TRINITY  
PARKWAY  
DESIGN  
CHARRETTE  
REPORT

FINDINGS AND RECOMMENDATIONS OF  
AN INDEPENDENT PROFESSIONAL REVIEW OF  
THE TRINITY RIVER PARKWAY  
APRIL 2015

RECOMMENDED ACCESS POINTS TO PARKWAY

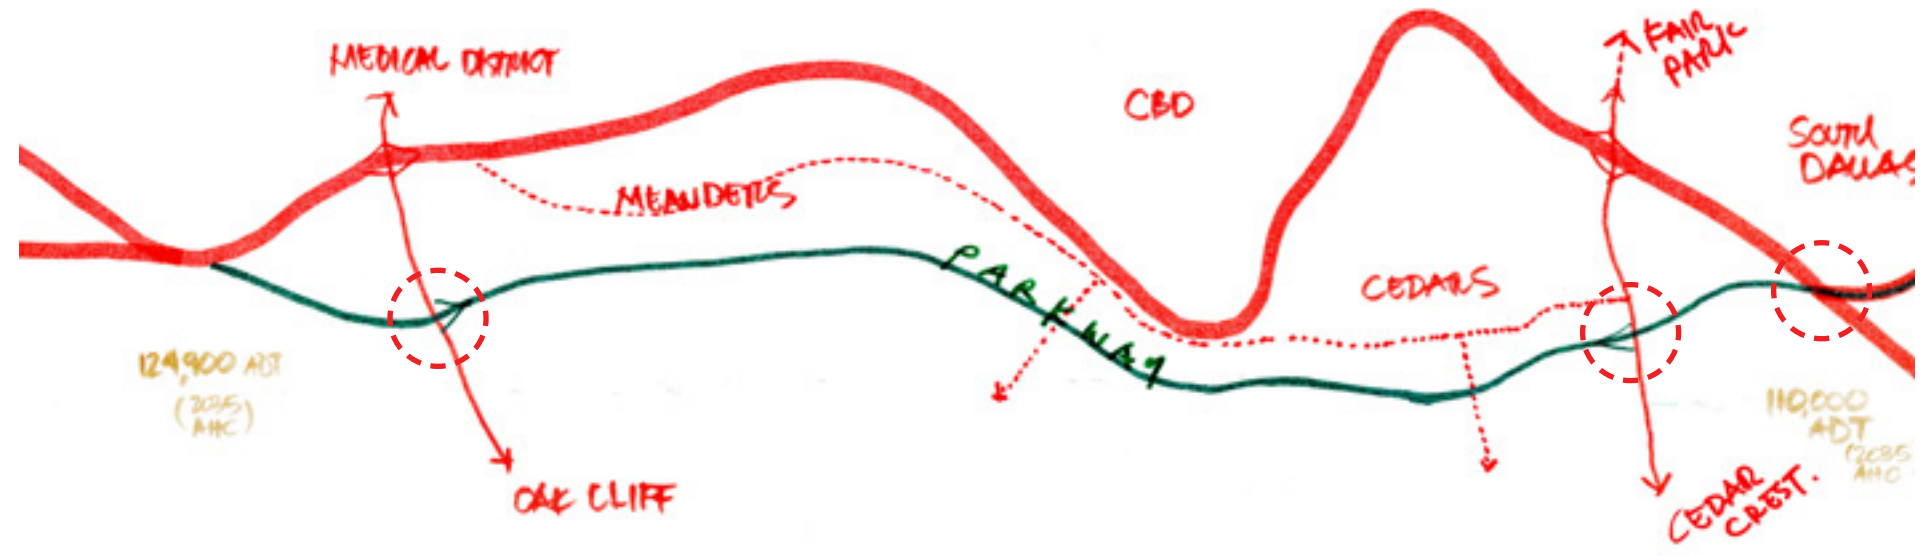
PRIMARY  
**VARIATION #2**  
 BUILD FEWER RAMPS. ONLY BUILD TWO SET OF RAMPS ACCESSING THE INNER CITY FOR THE FORESEEABLE FUTURE: 1 ON/OFF PAIR AT THE NORTH END NEAR THE MEDICAL DISTRICT AND 1 ON/OFF PAIR AT THE SOUTH END NEAR CEDAR CREST.

Later when development is underway a final, third on/off pair at the high-density center adjacent to big development sites if this assists such development - but with a less impactful, low-profile design).

FLOODING HISTORY 1908 - 2014

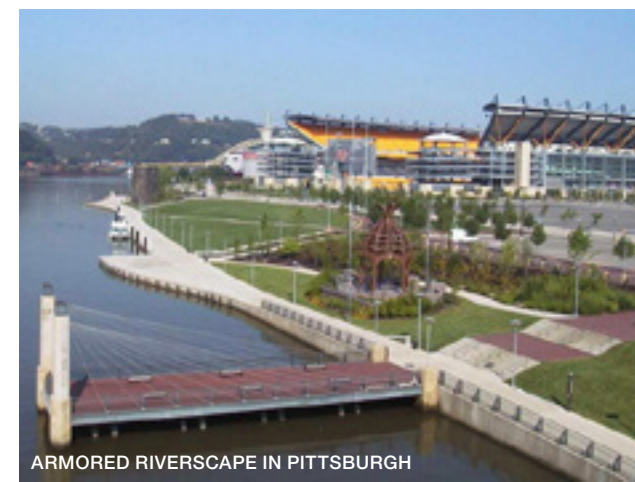
to confidently project and that projections beyond this timeframe are very speculative. Second, it was enlightening to understand the actual historic pattern of floods of the river corridor based on measurements regularly documented so that an informed judgment might be made about tolerance for floods of the parkway moving into the future. We felt the 100-year flood standard is somewhat excessive.

POST CHARRETTE RENDERING OF PARKWAY AND PARK ACCESS POINT FROM INWOOD RD BRIDGE

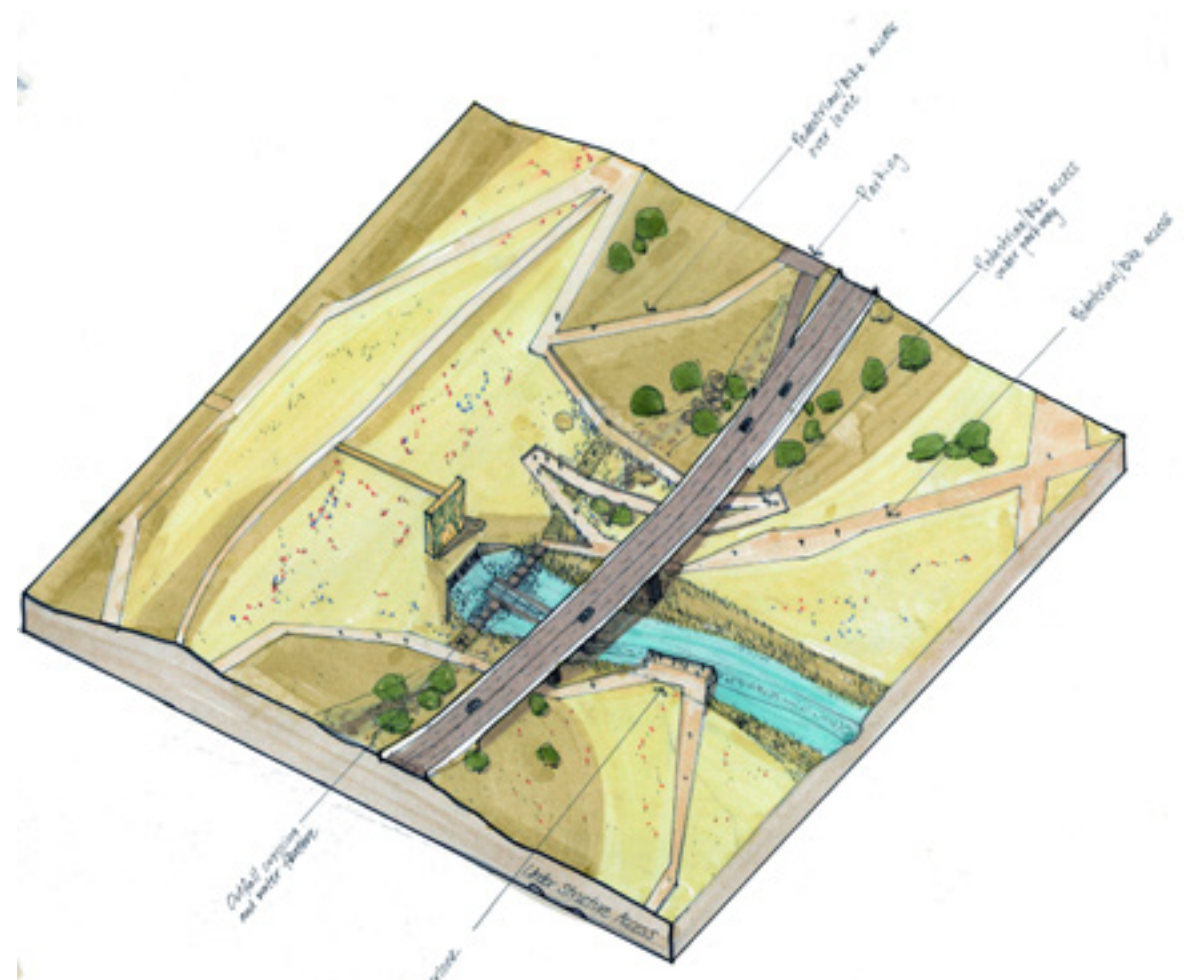
An optimal solution would be to refine the design to a 10-year flood standard, acknowledge the occasional flooding of the parkway, in order to open up major views for parkway users. If the experience of occasional flooding of the parkway (probably about once in a decade for a day or so) is not found to be acceptable to the people of Dallas, then an acceptable solution would be to refine the design to a 50-year flood standard or even stay with the 100-year flood standard but using berms and other methods other than blank walls wherever practical, thus at least creating close-in attractive views of park character for parkway users.
